Technical Service Bulletin

Number: 23-23-99

Rear Door Glass Will Not Roll Down All The Way

2000 (PL) Neon

FIGURE 1

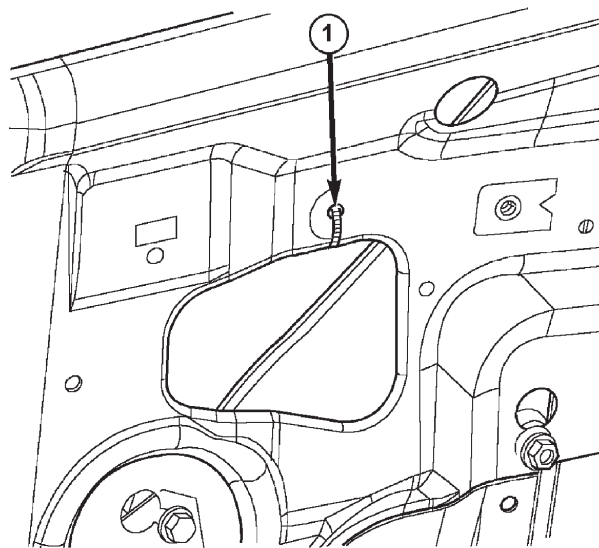
1. Remove the rear door trim panel and partial watershield to access the conduit clip using the procedure in the 2000 Neon Service Manual (publication No. 81-270-0025) 23-40.
2. Roll the rear door side window to the full up position.
3. Remove the conduit clip from the regulator conduit and discard (Figure 1).

1-	Access Hole
2-	Conduit Cable Clip Attaching Hole
3-	Conduit Cable Clip

FIGURE 2

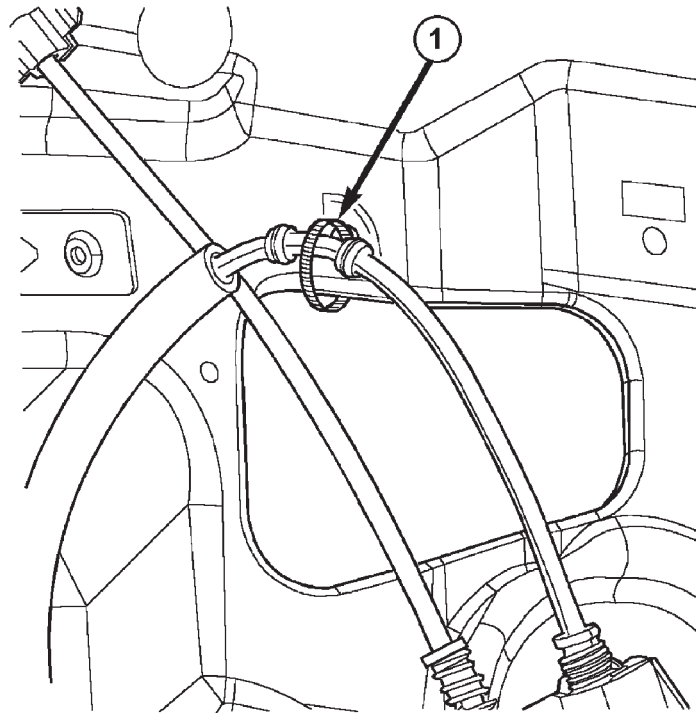
1-	Plastic Tie Strap
----	-------------------

- 4. Route plastic tie strap through conduit attaching hole, around conduit and back through access hole to securely fasten conduit to door inner panel (Figures 2 & 3).
